CERTIFICATE OF APPROPRIATENESS

Property: 1714 South Boulevard, Tract 7A & 8A, Block 4, West Edgemont Subdivision. The property includes a historic 5,255 square foot two-story wood frame single-family residence and a detached garage situated on a 17,745 square foot (105' x 169') interior lot.

Significance: Contributing Colonial Revival residence, constructed circa 1929, located in the Boulevard Oaks Historic District.

Proposal: Alteration – Front entry, shutters, side and rear addition

ARCHIVES – DATE UNKNOWN

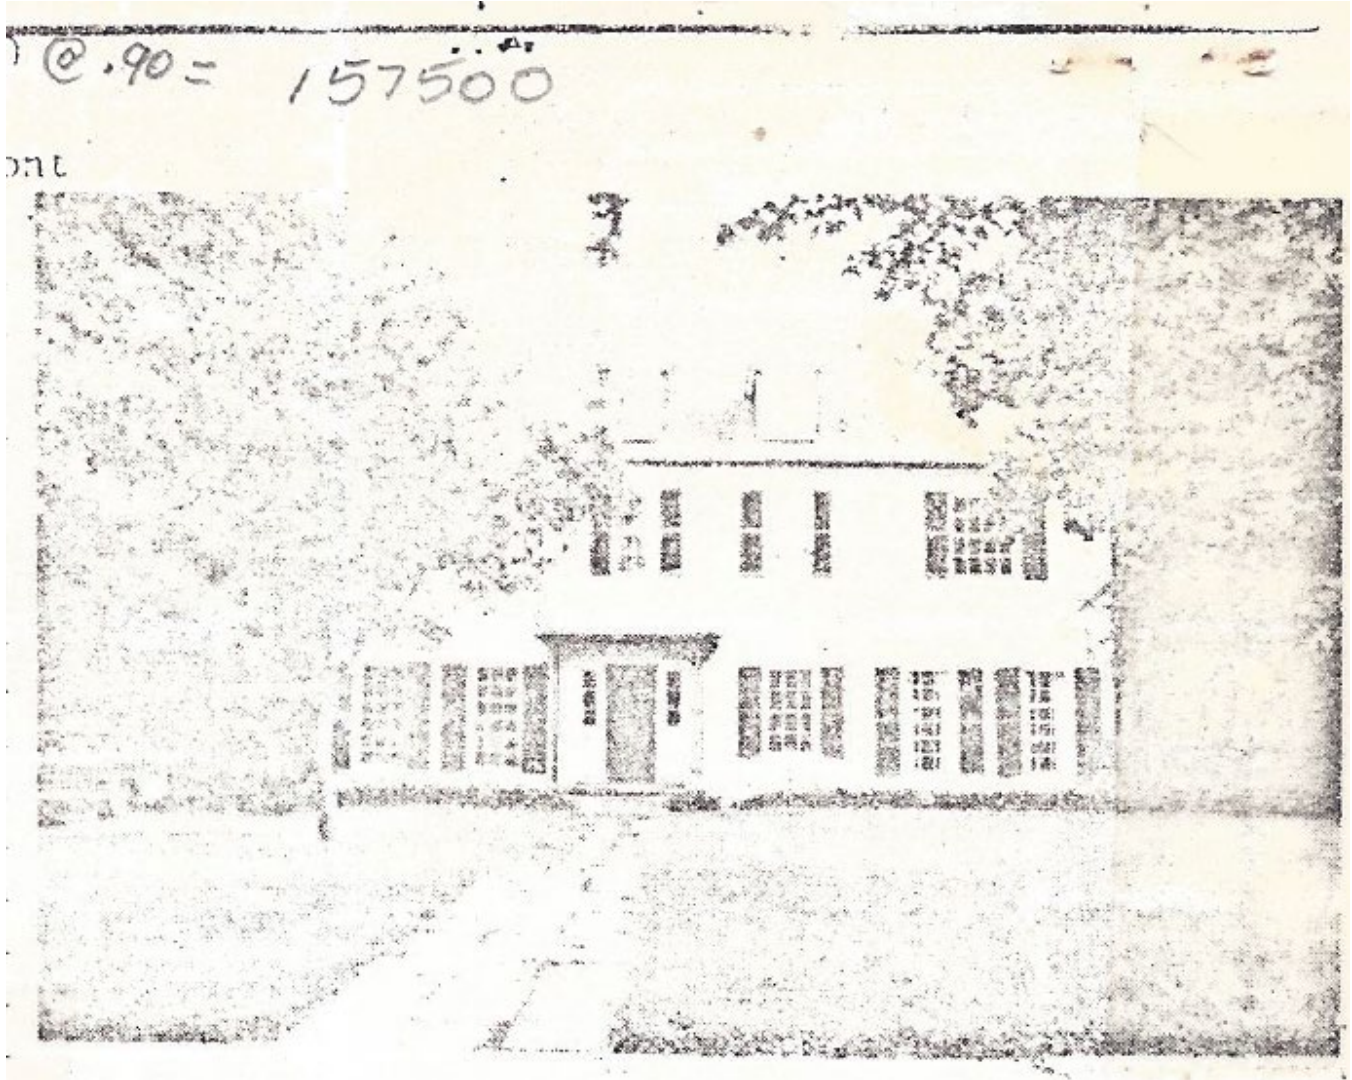
no front entry columns etc

EAST SIDE ELEVATION

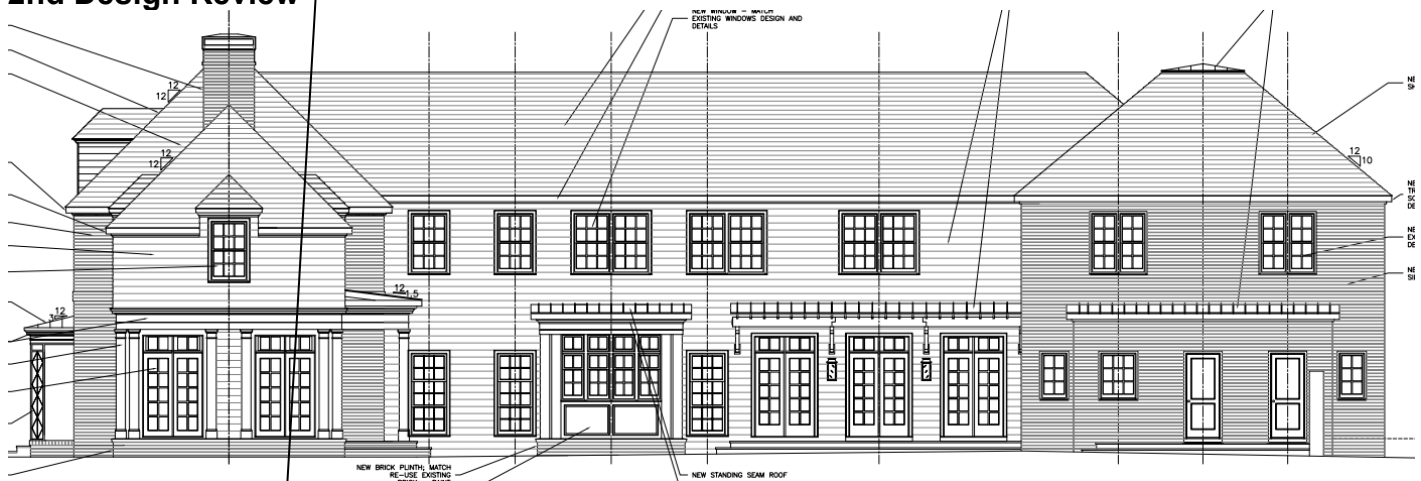
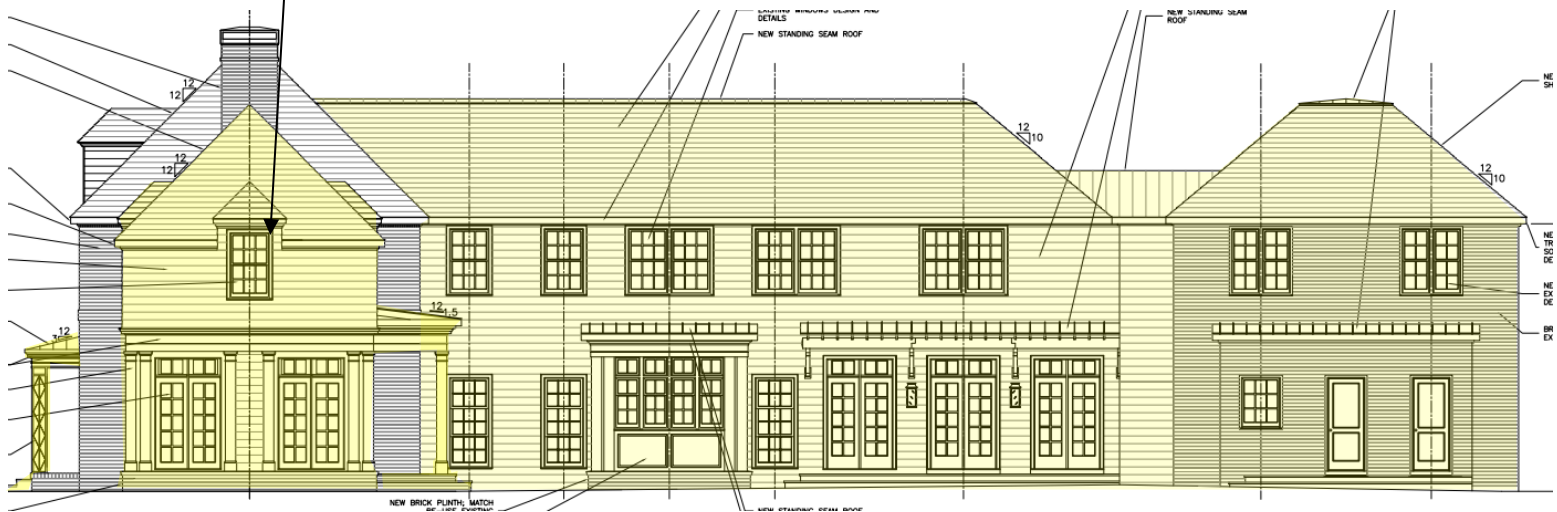
Recommendation: **Approval with conditions: applicants update window lite pattern to 1/1, reduce lite pattern on French door openings with single lite transoms (to be reviewed by staff); eliminate decorative pilasters/columns visible from the street on the south (front) and east (side) elevations. Align top of 2nd floor windows on east side addition with the height of historic windows.**
